Revised Engineering Plan Submittal for the March 10, 2022 Hearing

Re: Extra Space Storage, LLC – Totowa PB (the “Applicant”)
930 Riverview Drive; Block 169, Lot 6 QC000A (the “Property”)

**RE: Proposed Parking Lot Improvements
Block 169, Lot 6
930 Riverview Drive (County Route 640)
Borough of Totowa, Passaic County, New Jersey**

The following is an itemized response to the comments contained within the Richard A. Alaimo Engineering review letter dated February 7, 2022::

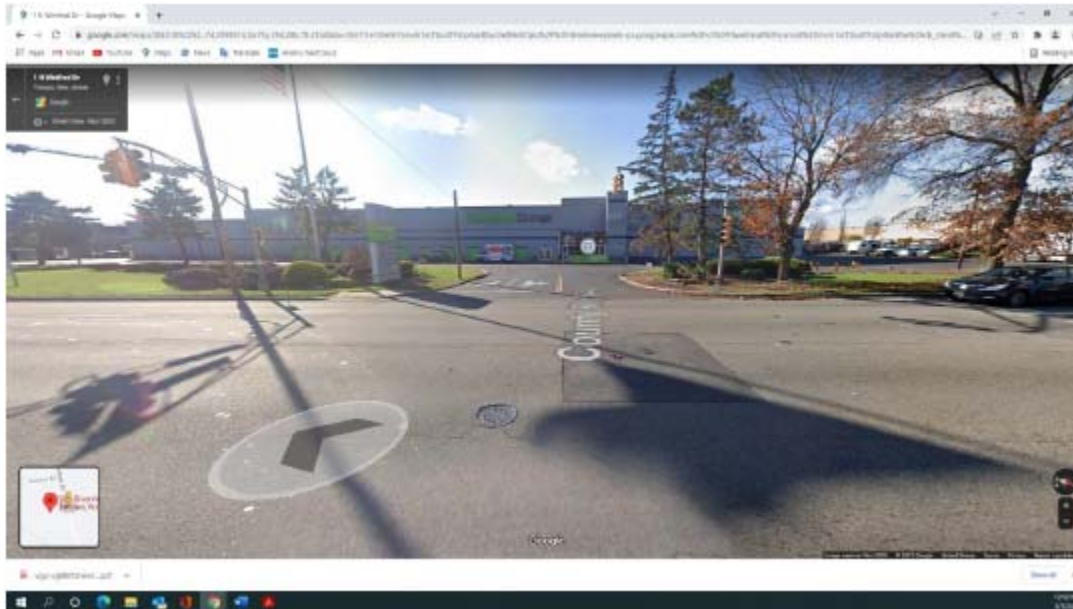
1. The current site is in the I-3 Industrial Zone and it contains a building which is internally subdivided to provide for several tenants, one of which is the applicant, Extra Storage. The site has adequate parking for all the current tenants plus additional space was created and approved at the Zoning Board to stage Hello Fresh vehicles. The current applicant, Extra Storage, is proposing to designate and screen areas for overnight storage of vehicles which they are not currently permitted to do.

Acknowledged.

4. [View from residential side of Riverview](#)

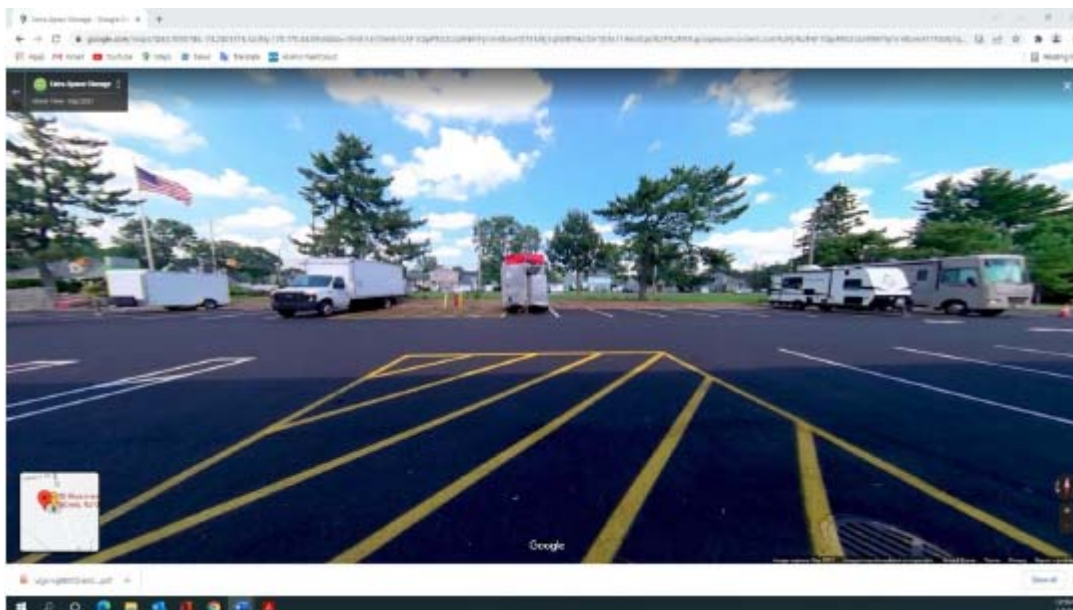
3. The location and need for the outside storage must be justified by the applicant. The Extra Storage Space fronts on Riverview Drive and there is a residential zone directly across the street. There is parking now facing across into the residential zone which can be intrusive via shining headlights. The proposed outdoor storage will also be visible since it is proposed in front along Riverview Drive and on the two front sides of the building.

Testimony will be provided.
